RE: Sydney Modern – Accessible Car Parking

MGAC has been engaged to assess the provision of accessible car parking outside the entrance pavilion on Art Gallery Road.

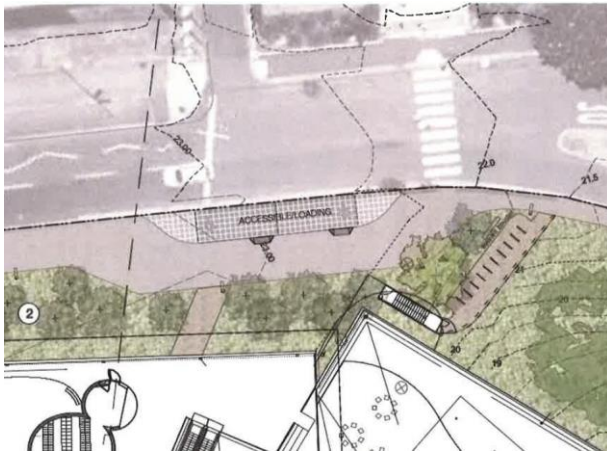
The approved Landscape SSDA drawing is shown below. The layout shows the overlap by the road bridge construction. From the information provided, the Arup (Structural) analysis of the original drawings for the AGR Bridge, determined that the cantilevered footpath portion could not support any significant load, nor could it be removed.

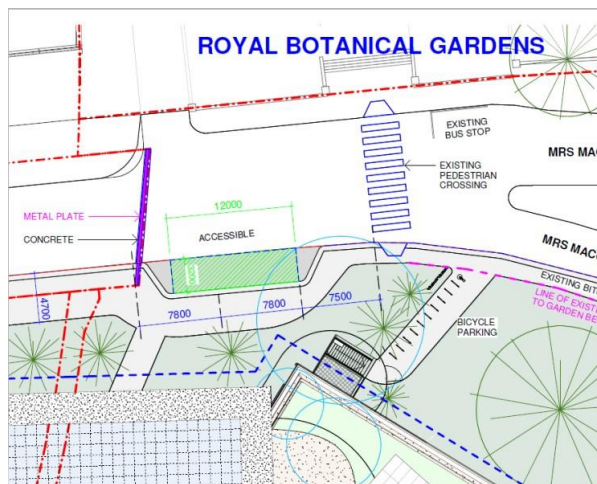
From the information provided, the Civil design for Tender created 1 accessible car bay. This accessible car bays has a size of 12.0 m x 3.2m, to meet the requirements of AS2890.6.

The current architectural site plan has adopted the Civil strategy to provide a single accessible car bay. The accessible car bay is adjacent a new 4 metre wide footpath, which meets the existing 2 metre wide footpath.

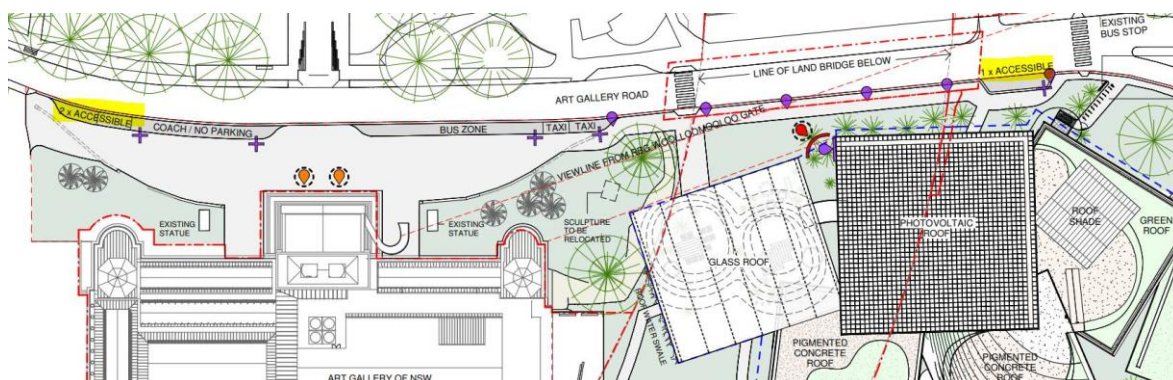
From the information provided by the Art Gallery of NSW, all of the existing public parking (ticketed) in front of the existing building will be removed as part of the approved works, with 2 accessible spaces being retained in this location. This will therefore be a total of 3 accessible parking spaces, which therefore make up 100% of the new parking along Art Gallery Road (excluding taxi, bus and coach parking).
